Taco Time

PROJECT DESCRIPTION
CONSTRUCTION OF NEW RESTAURANT BUILDING, EXPANSION
OF EXISTING PARKING LOT WITH ASSOCIATED CIVIL IMPROVEMENTS.

Cover Sheet

Paving & Storm Plan

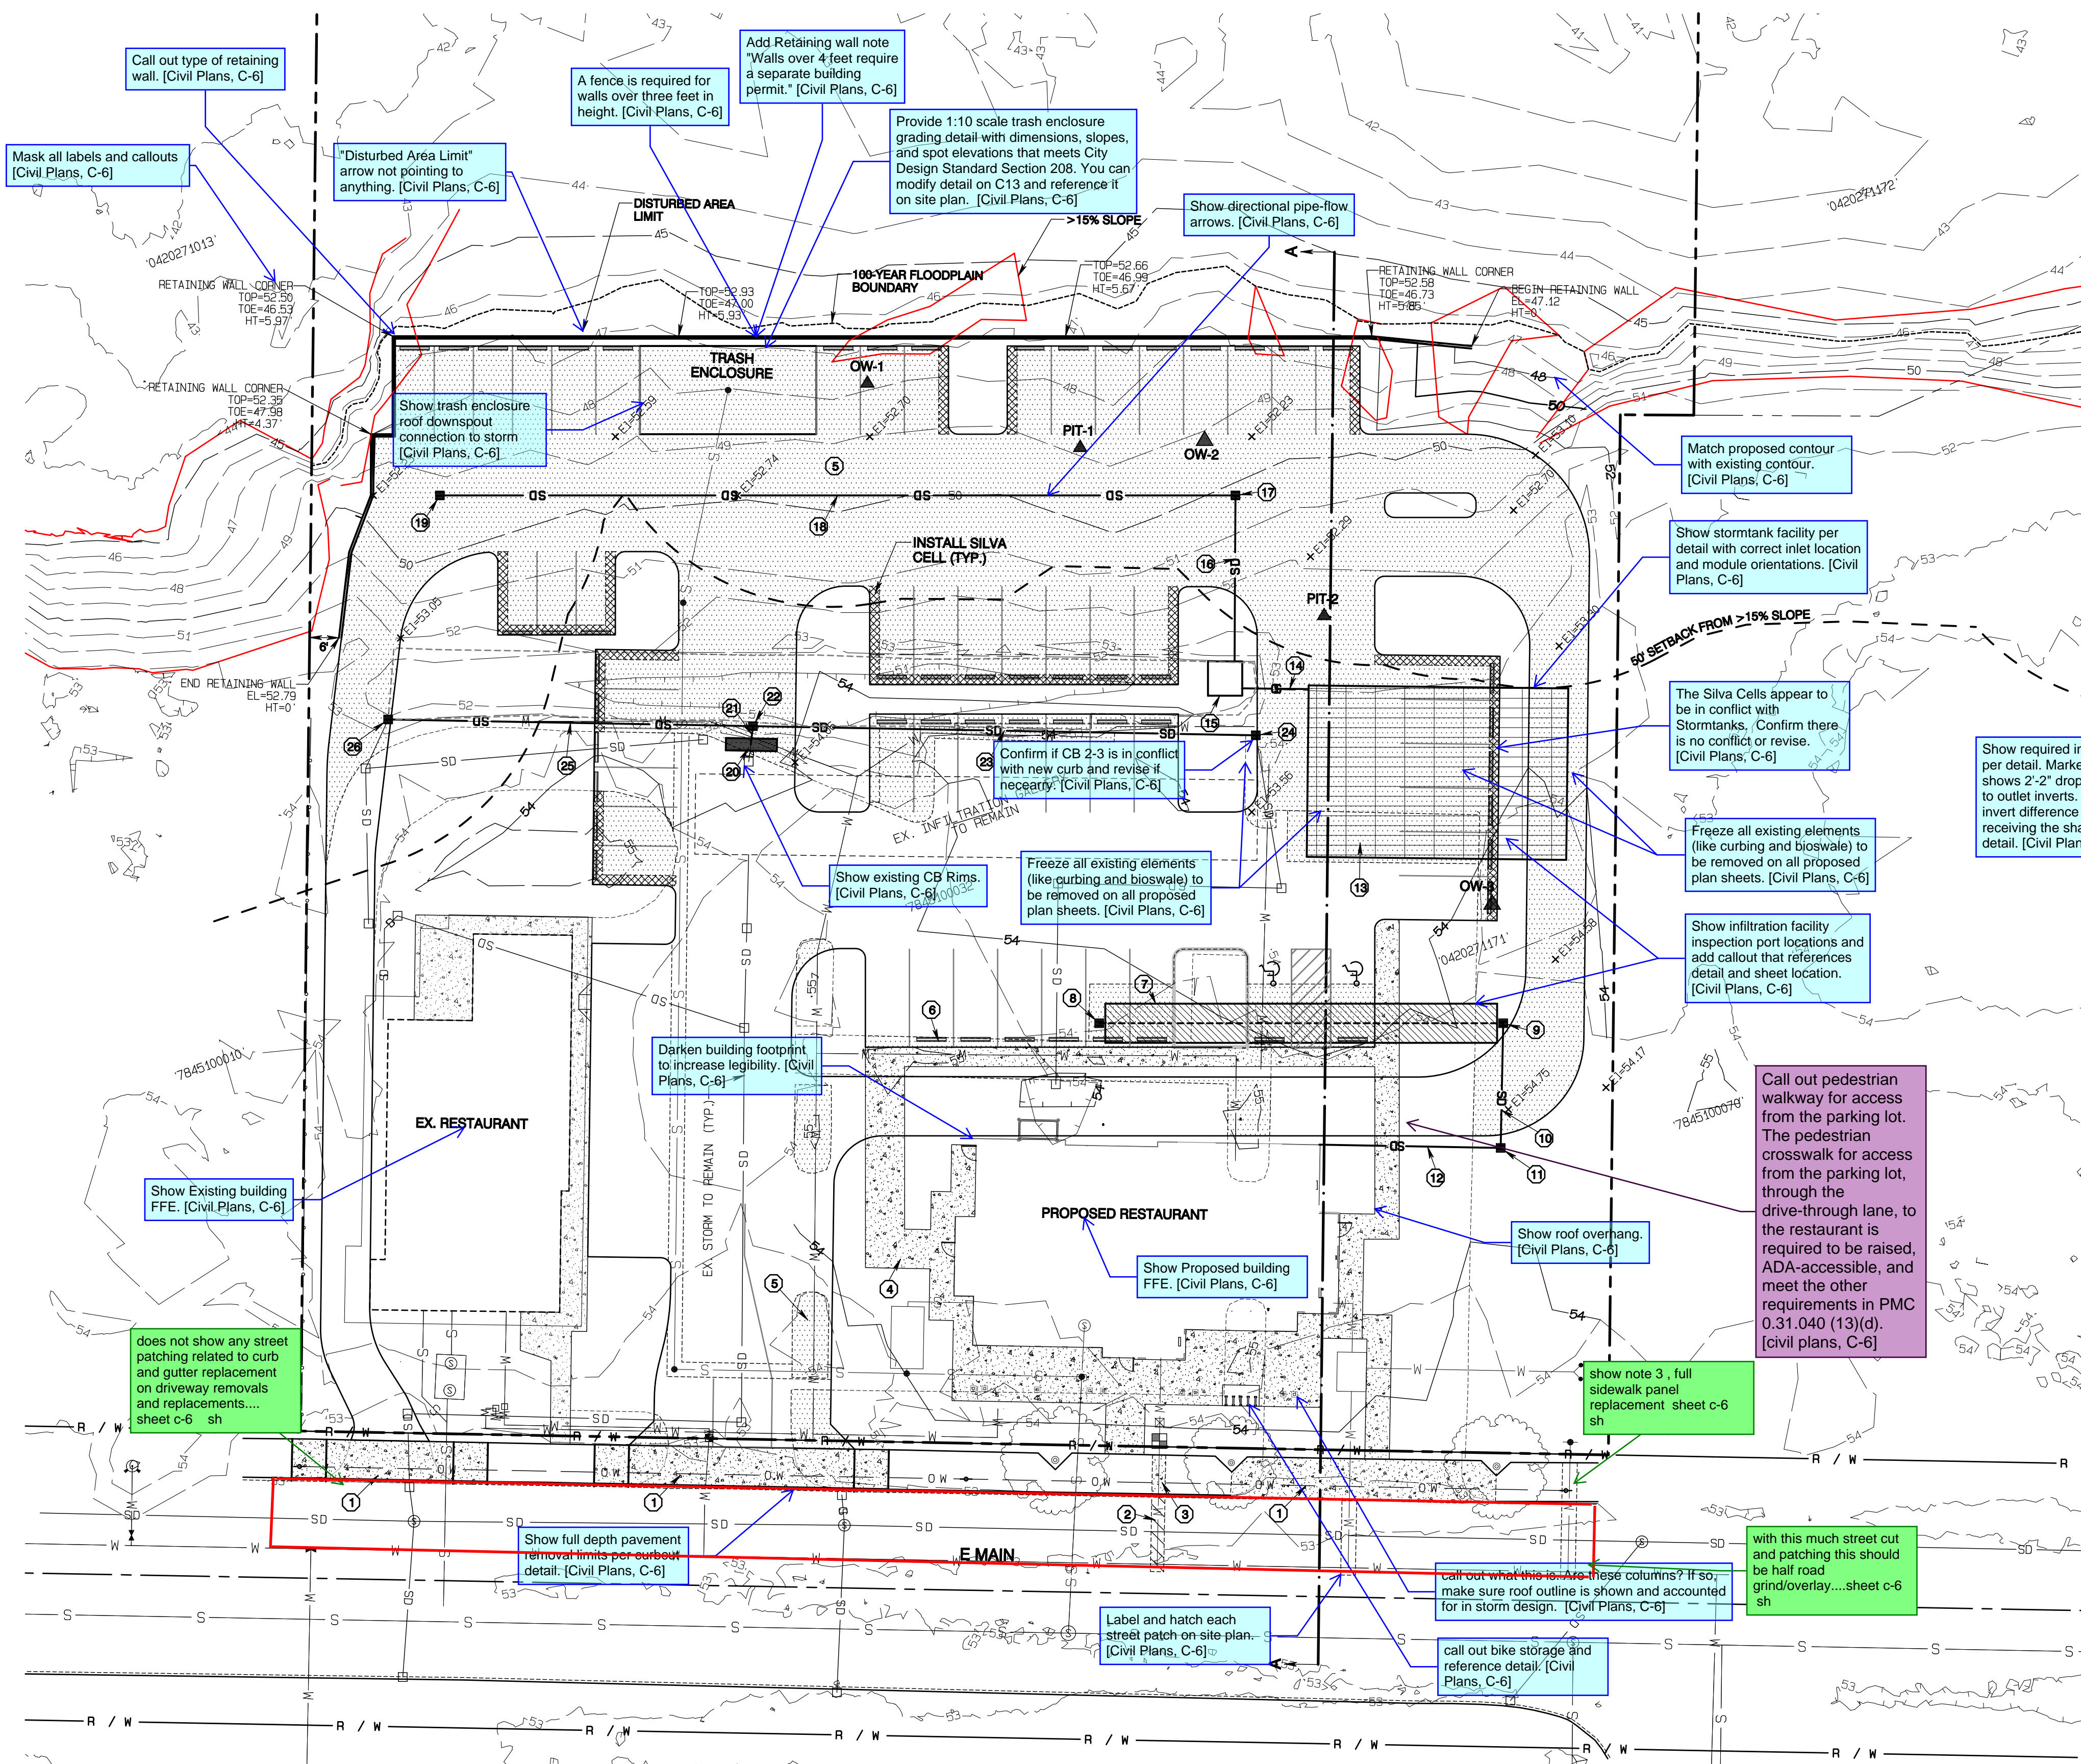
Roof downspout Detail is not in plans. Provide City roof downspout infiltration detail 02.05.01 and site specific detail as mentioned in comment on sheet C10. [Civil Plans, C-6]

What is JB? Reference detail. [Civil Plans, C-6]

This says storm-tanks are 2 feet deep, the profile appears to show it at about 3.5 feet deep [Civil Plans, C-6]

Reference applicable structure details and Sheet Number where details are located. [Civil Plans, C-6]

Pipe cover at CB 1-2 is approximately 0.65 feet. Minimum cover for Ductile Iron Pipe is 1 foot. [Civil Plans, C-6]

3.52 foot drop from rim to invert exceeds the 3.3' max drop for the provided detail. Revise invert to meet detail specs. [Civil Plans, C-6]

Pipe cover at CB 2-3 is approximately 0.9 feet. Minimum cover for Ductile Iron Pipe is 1 foot. [Civil Plans, C-6]

Paving and Storm sheet is busy. Separate Paving Plan from Storm Plan. Remove topography and utility lines from paving plan and rename it as Site Plan. [Civil Plans, C-6]

Remove structures from keynotes and label structure names and numbers on plans. Use a separate structures table for rim and invert elevations. [Civil Plans, C-6]

Call out all proposed improvements and reference applicable details. [Civil Plans, C-6]

All ADA curb ramps, ADA stalls, and Driveways must have 1:10 scale details showing dimensions, spot elevations, and slope arrows. [Civil Plans, C-6]

Add Pipe materials note stating, "Ductile iron pipe shall be Class 50, conforming to AWWA C151. Minimum cover on ductile iron pipe shall be 1-foot. PVC pipe shall be per ASTM D3034, SDR 35 for pipe size 15-inch and smaller. Minimum cover on PVC pipe shall be 3-feet." [Civil Plans, C-6]

Add Stormwater Plan Notes from City Standard Section 207. [Civil Plans, C-6]

Add note for contractor to clean existing infiltration trench per maintenance Manual and Ecology standards prior to end of construction. [Civil Plans, C-6]

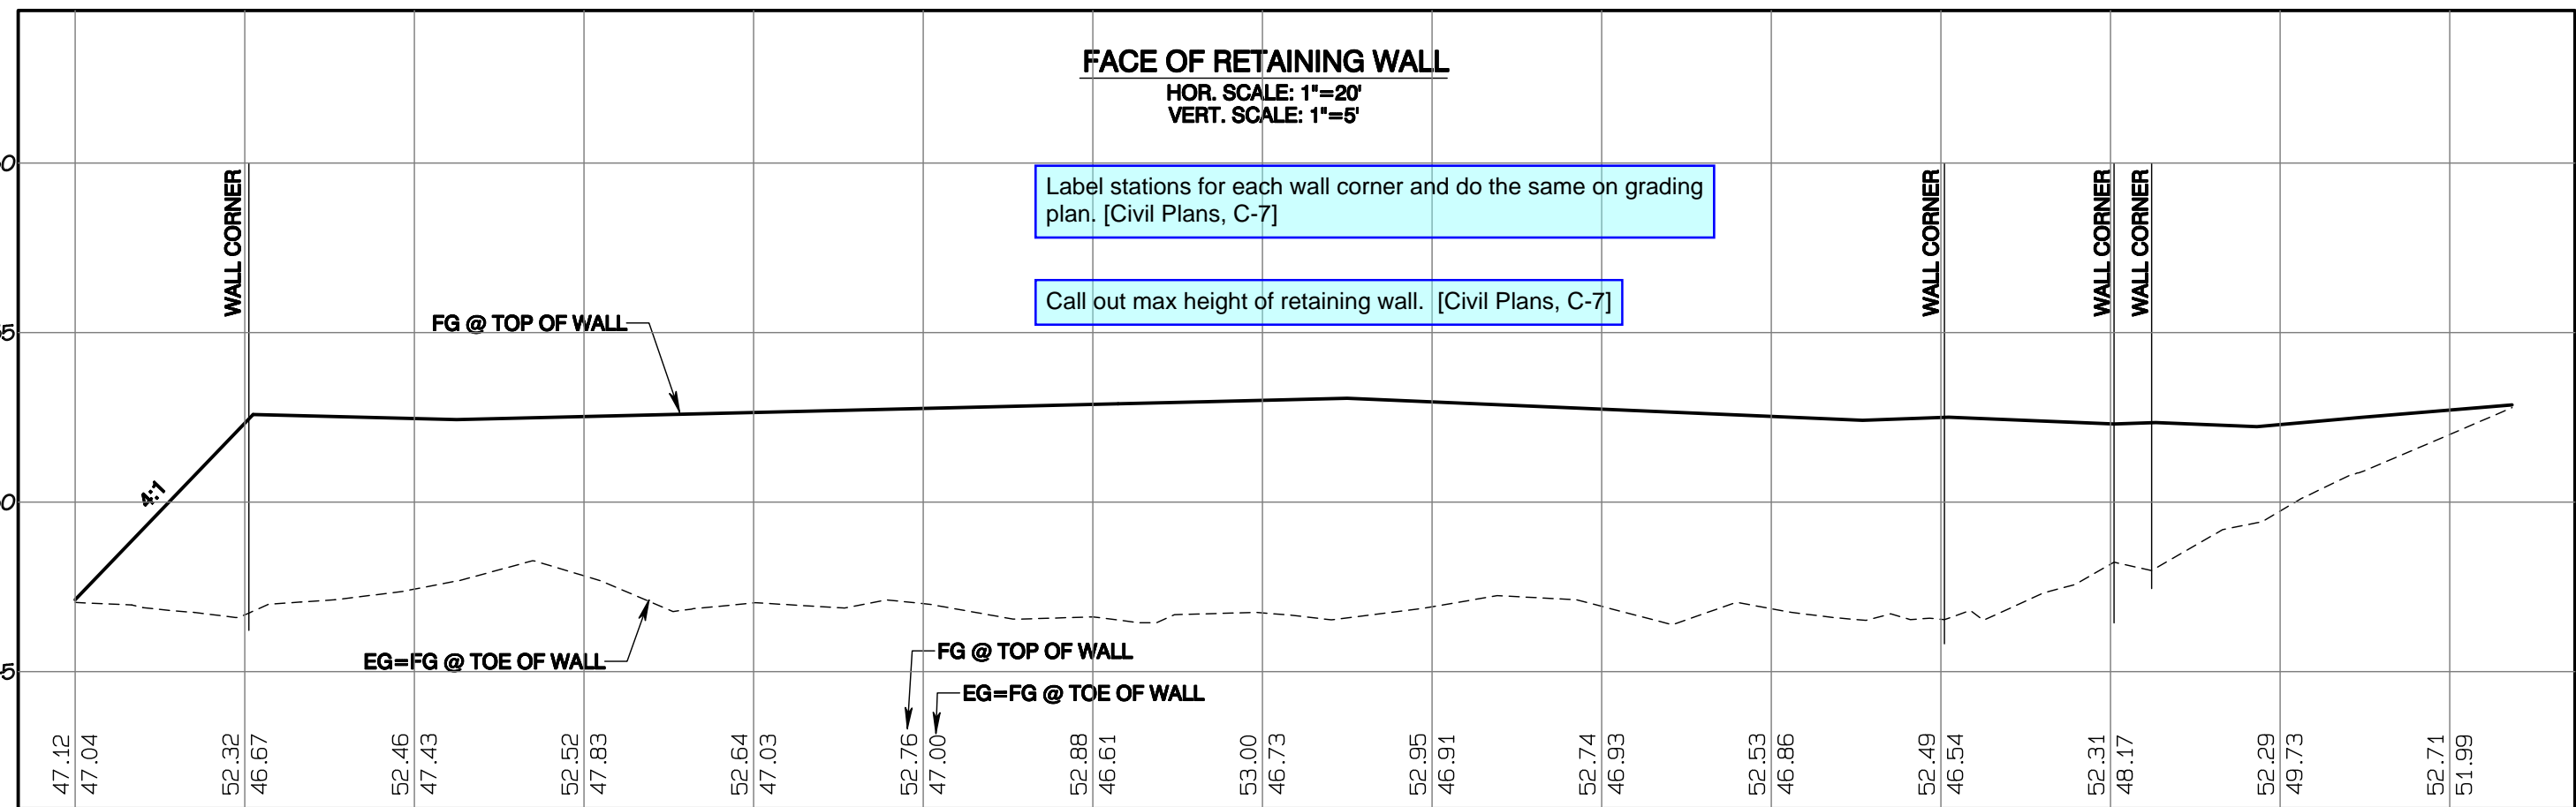
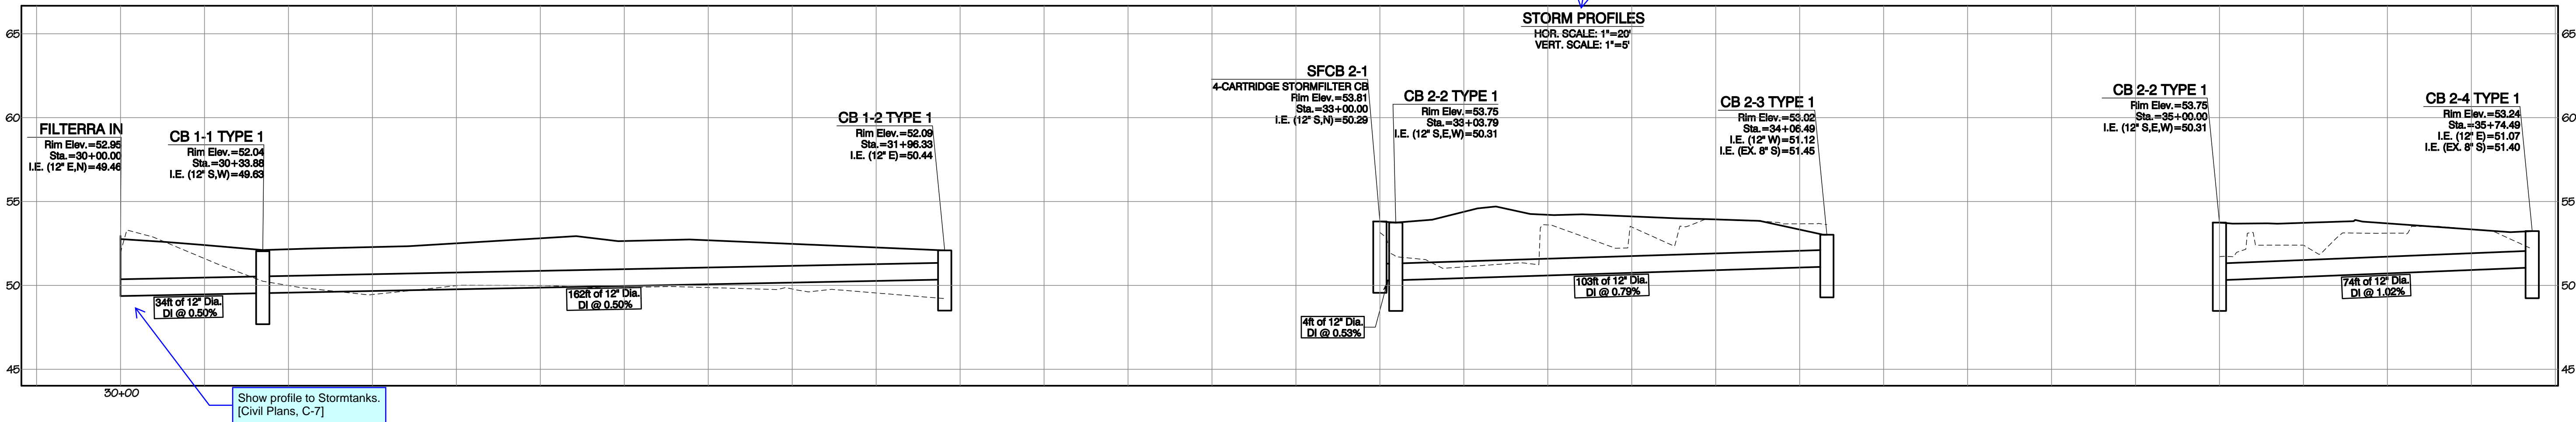
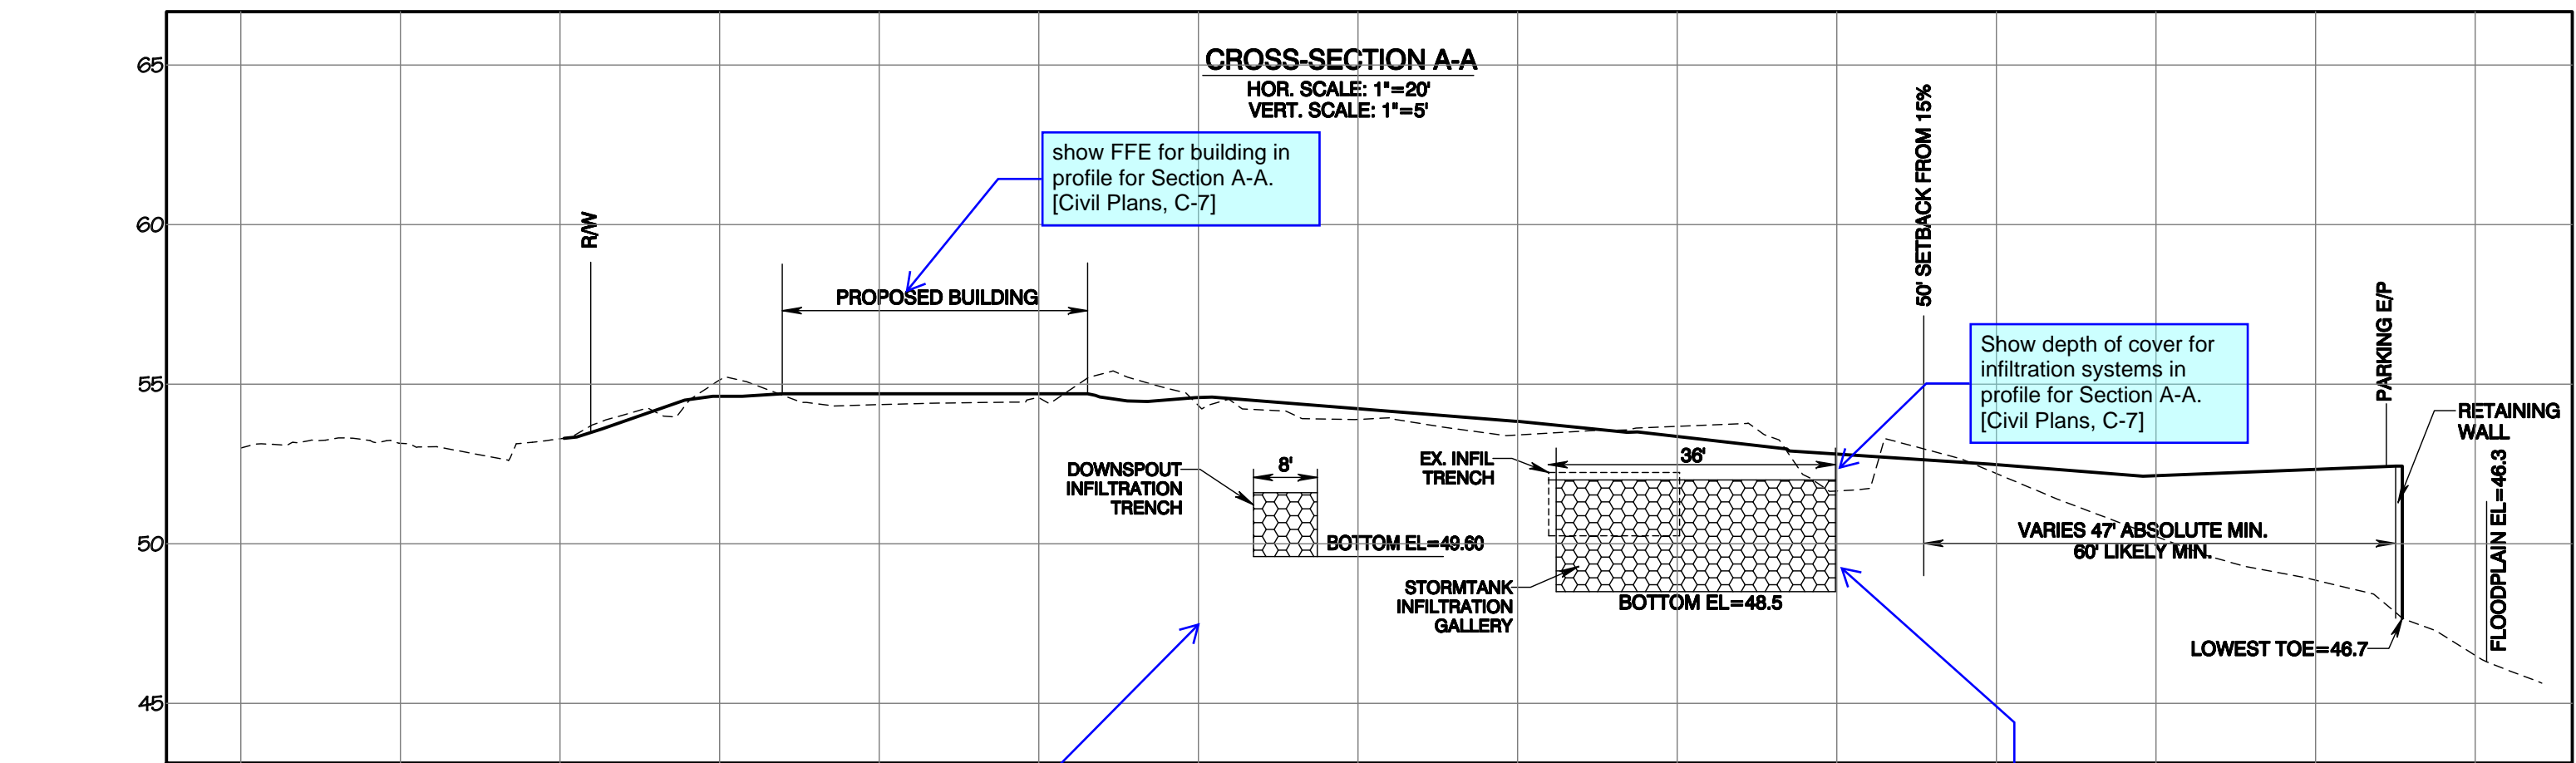
Per COP Design Standards Section 2.2, the consistency between the horizontal scale and the vertical scale shall be on a ratio of 10 to 1 (i.e., 1" = 20' horizontal; 1" = 2' vertical). [Civil Plans, C-7]

Provide Station and existing/proposed elevation labels on bottom of each profile view. [Civil Plans, C-7]

Mask and "bring to front" the order for all Profile View labels and titles to avoid grid lines intersecting text. [Civil Plans, C-7]

Label existing and proposed surface. [Civil Plans, C-7]

clarify by adding "pipe-run" in between storm and profiles. [Civil Plans, C-7]

Provide profiles of each proposed storm facility showing other facilities on in close proximity (filterra, silva cells, etc.) cover depth, inverts, storage layers, ponding limits and, high water elevations. show section labels on storm plan Plan. [Civil Plans, C-7]

Label stations for each wall corner and do the same on grading plan. [Civil Plans, C-7]

Call out max height of retaining wall. [Civil Plans, C-7]
